APPLICATION FOR A CERTIFICATE OF APPROPRIATENESS – STAFF REPORT

098-17-CA 506 N BOUNDARY STREET Applicant: TACTILE WORKSHOP

<u>Nature of Project</u>: Construct rear addition; replace rear retaining wall; replace rear patio Staff Notes:

5.1 PLOT PLAN

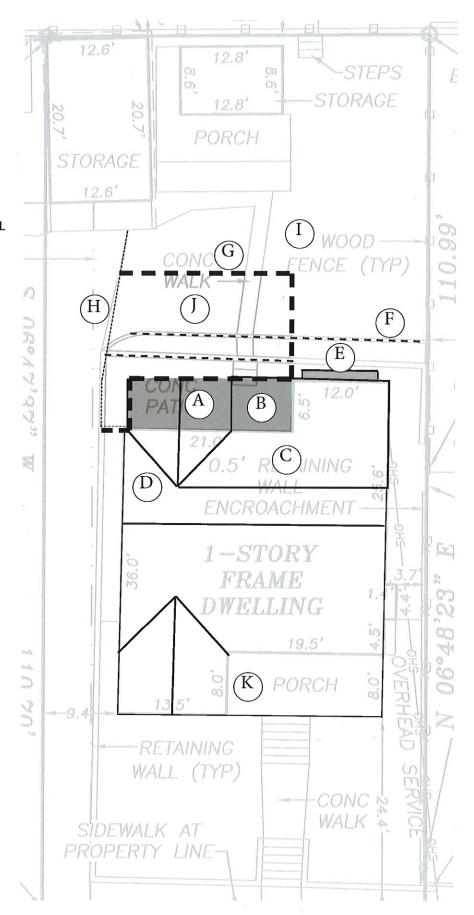
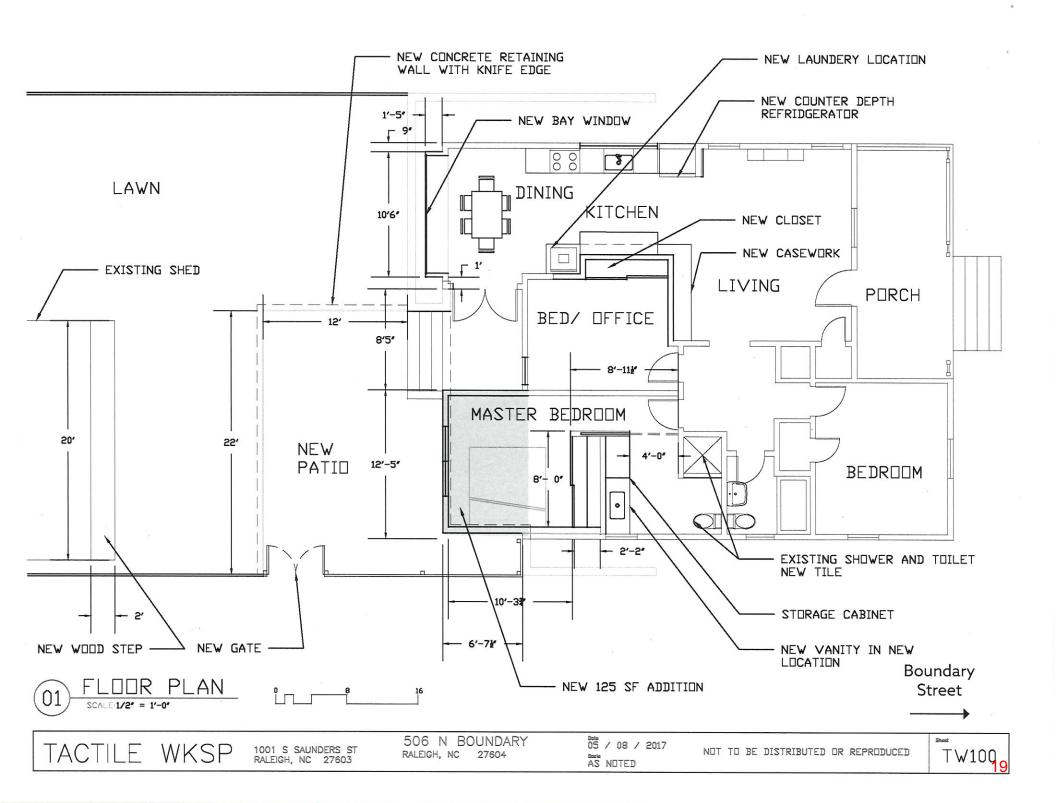
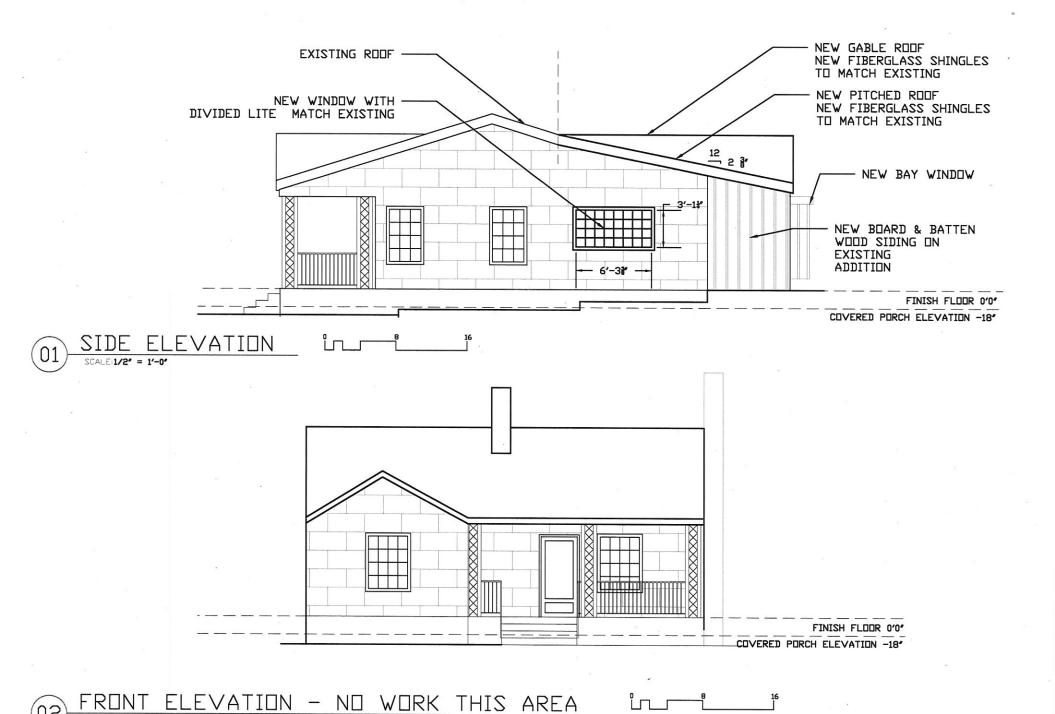
- A. Replacing the rear retaining wall, replacing the rear patio, constructing new wood steps to the shed, and adding a new wood gate is not incongruous in concept according to *Guidelines* 1.3.1, 1.3.2, 1.3.4, 1.3.6, 1.3.7, 1.3.8, 1.3.9, 1.3.13, 1.4.4, 1.4.8, 1.6.7, and the following suggested facts:
- 1* There are no trees in the backyard.
- 2* The patio is not historic. The new patio will measure approximately 22' x 15' and will be made from gray concrete pavers and pea gravel. Samples were not provided.
- 3* The existing backyard includes two non-historic brick retaining walls relatively close to the back of the house. The applicant proposes to remove both walls to allow for the new rear

- addition, as well as to create more outdoor space at the same level as the interior floor height.
- 4* A new retaining wall is proposed to be built approximately 15′ back from the new rear addition. The wall will be made from concrete with a low profile knife edge cap.

- 2* The applicant proposes adding a 1-story rear gable front addition clad in board and batten wood siding that projects the same depth as the existing rear addition and into the current patio area.

- 3* The space between the 12′-5″ wide new addition and the existing addition will be a covered porch..
- 4* A new roof is proposed to cover the new porch and existing rear addition.

- 5* A bay window that extends 1'-5" and measures 10'-6" wide is proposed for the rear of the existing addition. The new bay and entirety of the addition are proposed to be clad in wood board and batten siding.

- 12* At the rear of the house the portion of the roof that is not affected by the new addition will be altered to a shallower pitch. All new roof areas will match the existing gray fiberglass shingle roof.

Staff suggests that the committee approve the remainder of the application, with the following conditions:

- 1. That details and specifications for the following be provided to and approved by staff prior to the issuance of the blue placard:
 - a. Windows.
- 2. That details and specifications for the following be provided to and approved by staff prior to installation:
 - a. Doors;
 - b. Porch steps;
 - c. Patio material;
 - d. Lighting fixtures;
 - e. Materials of the ceiling of the porch roof;
 - f. Paint samples;
 - g. Steps to rear outbuildings.
